Technical Bulletin

Bulletin Number: TB1008

Subject: Strangler Valve Protection Device

Image 1. Image shows position of connection flange as fitted to 3126DITA engine.

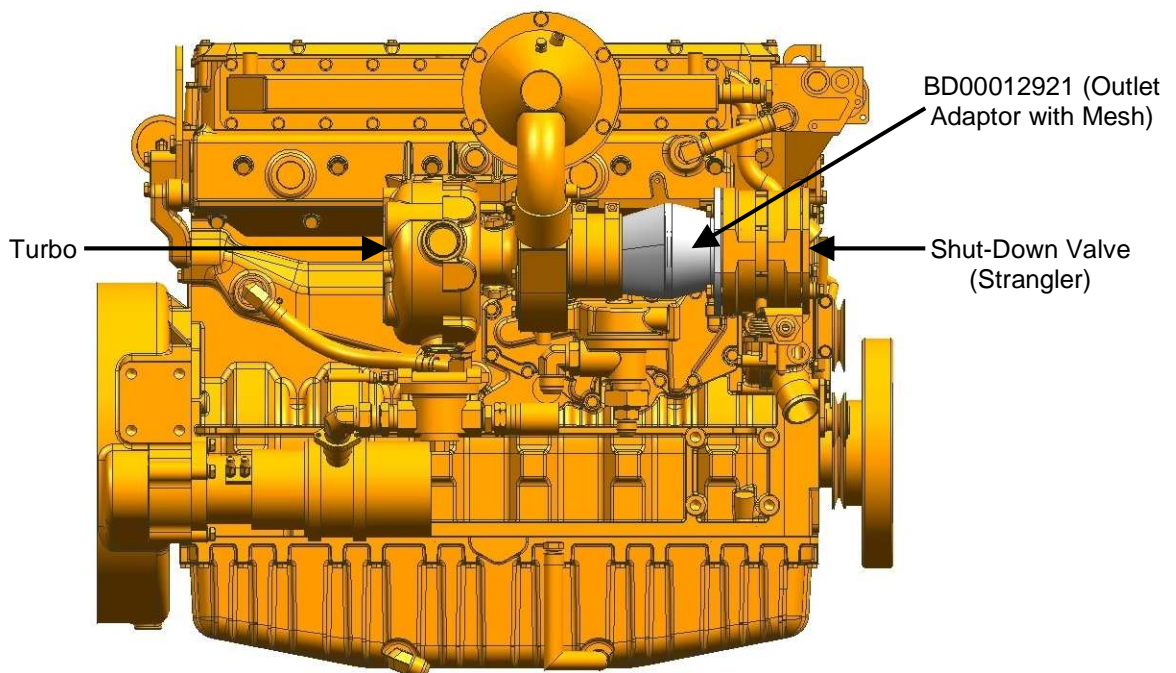
Sandvik has upgraded the connection flange between the turbo and the strangler valve p/n BD00012921. The new design incorporates a stainless steel mesh guard to stop a broken turbo impellor shaft from entering into the strangler valve operating area. (Please refer to images 1 and 2).

Sandvik recommend all owners/operators of 3126DITA Diesel Engine Systems install this new connecting flange at the next major service.
